ISO/IEC
14496-10

Seventh edition
2012-05-01
AMENDMENT 1
2013-07-15

Part 10:
Advanced Video Coding

AMENDMENT 1: Additional profiles and supplemental enhancement information (SEI) messages

Figure D-12 – Rearrangement and upconversion of tile format packing arrangement (frame_packing_arrangement_type equal to 7)

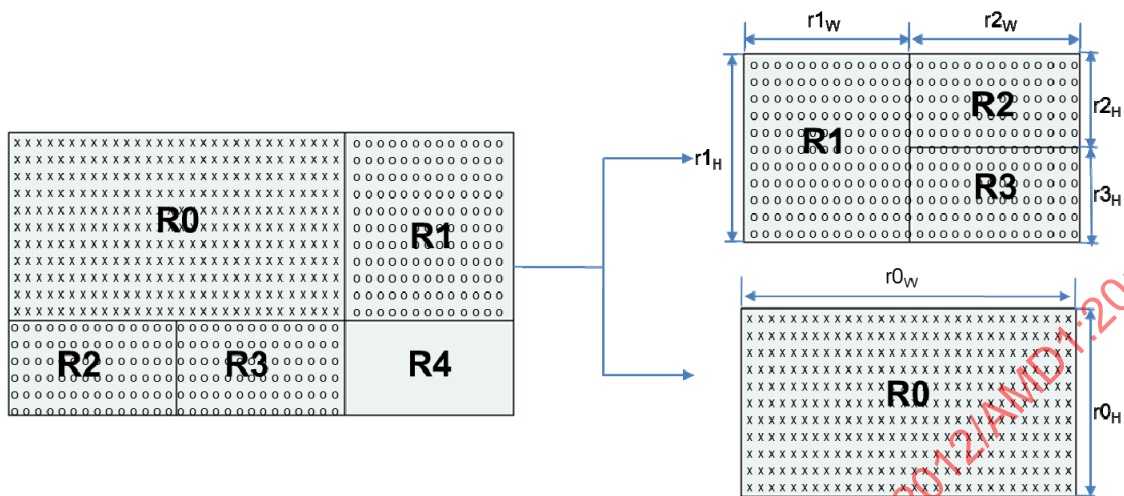
NOTE 7 – Figure D-12 provides an illustration of the rearrangement process for the frame packing arrangement scheme for the frame_packing_arrangement_type value of 7.

When frame_packing_arrangement_type is equal to 7, the frame packing arrangement is composed of five rectangular regions identified as R0, R1, R2, R3, and R4 as illustrated in Figure D-12.

*In D.2.25, add the following Figure D-12 after Figure D-11:*

When frame_packing_arrangement_type is equal to 7, constituent frame 0 is obtained by cropping from the decoded frames the region R0, and constituent frame 1 is obtained by stacking vertically the regions R2 and R3 and placing the resulting rectangle to the right of the region R1. The region R4 is not part of either constituent frame and is discarded.
